ROYAL OAK MINES INC., ENVIRONMENTAL SERVICES

**subject:** New stack ports for SO<sub>2</sub> CEMS system

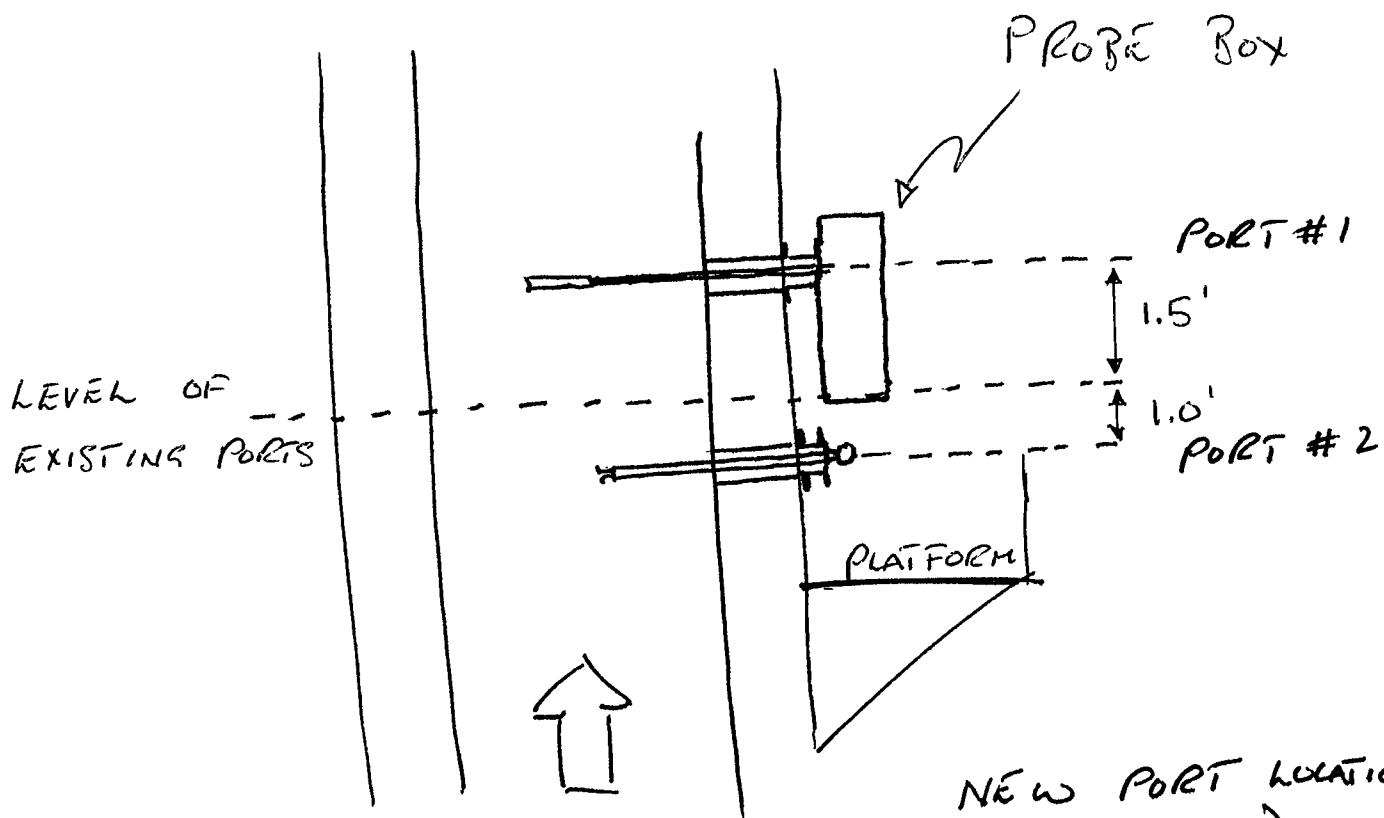
I've marked the locations of the two new stack ports. We were advised that the pitot tube port (marked as port #2) and the sample probe port (marked as port #1) should be in line vertically and that port #1 should be above port #2. Also, ideally, port #2 should be a foot or so above the elevation of the existing stack testing ports.

When I got up on the stack, I realised that there are some heavy straps around the stack, above the platform, that support a hoisting beam and the rail used for the stack testing probes. Given the height of the probe box, there will not be room to put the pitot tube one foot above the existing ports and the sample probe two-and-a-half feet above that (required by the dimensions of the probe box). I decided to put the pitot tube port one foot below the level of the existing ports and to put the sample probe port 1.5 feet above the existing port level. I decided to do this because the pitot tube assembly is only 50" in length from the inside face of it's flange plate. That puts the end of the pitot tube well in from the centre point of the stack and I don't think it will influence the flow near the manual sampling probe when they do their two traverses (which are 90° apart).

The locations for the two new ports are 2.5 feet apart, vertically, which leaves plenty of room for our 4" i.d. sleeves and flange plates. I have also located the new ports as close to the mid-point between the existing ports as possible (approx. 45° from each existing port), so that the new probes do not interfere with manual stack tests. Note that this puts the probe box outside the shack.

We should try to make the distance from the stack wall to the outside face of our flange as short as possible, so that the end of the pitot tube is as far from the stack wall as possible, where there is likely to be turbulence. Also, the sample probe and pitot tube have 3" i.d. flanges which we can't change, so we will have to put a 3" flange plate on the outside end of our sleeves.
